Technical Service Bulletin

Cobra Moto, LLC

TSB0426 CX65 Cylinder Stay Bracket

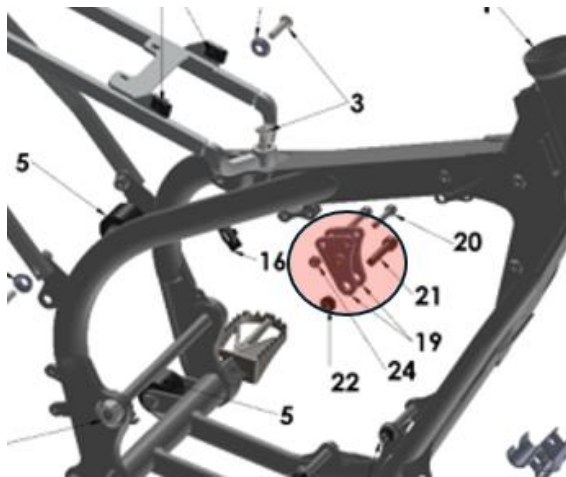
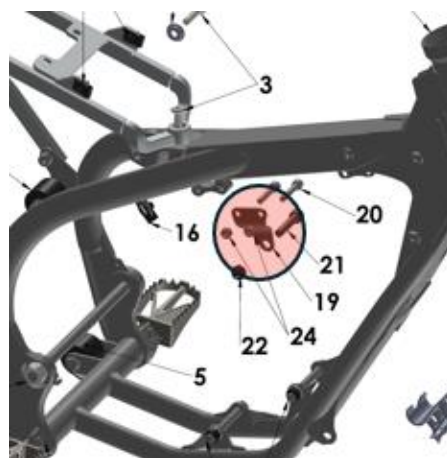
2024 – 2026 CX65's have two cylinder stay brackets (FCMU0117) that are too rigid together. Combined they subject the frame and back of cylinder to too high of stress.

Old dual bracket

New single bracket

Production is switching to a single "S" bracket which manages the stress between the frame and cylinder.

Your dealers will have a free kit that will replace these brackets with a single alloy formed steel "S" bracket. Please contact your dealer for this kit ASAP. Kit # FKC60004
